Technical Service Bulletin

Topic	Mulsanne rear suspension knock
Market area	Bentley: worldwide (2WBE),Hongkong-Macau (5HK)
Brand	Bentley
Transaction No.	2044308/2
Level	EH
Status	Released for publishing
Release date	Mar 12, 2019

Knock from rear suspension

Figure 2

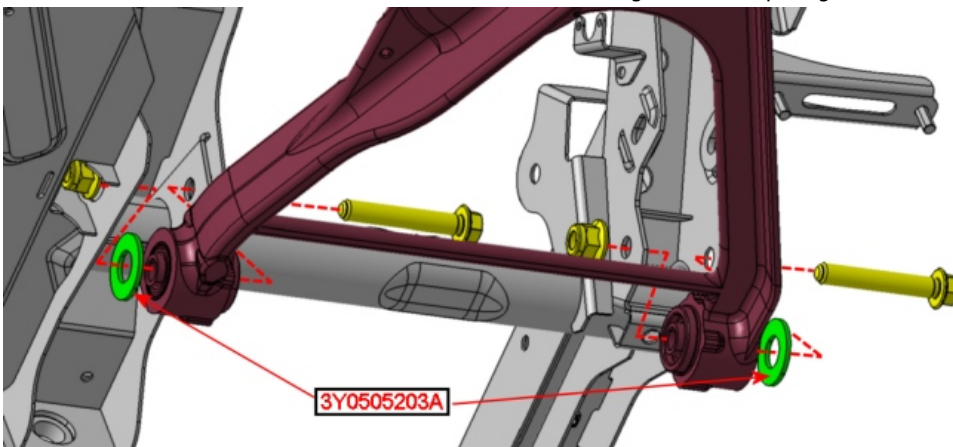
- Once the lower lever bushing is deemed to be serviceable then refit the lower levers Rep.Gr.42 incorporating one new isolation washers (part number 3Y0505203A) between the outer edge of each inner bushes and the rear subframe (see Figure 2 and 3)
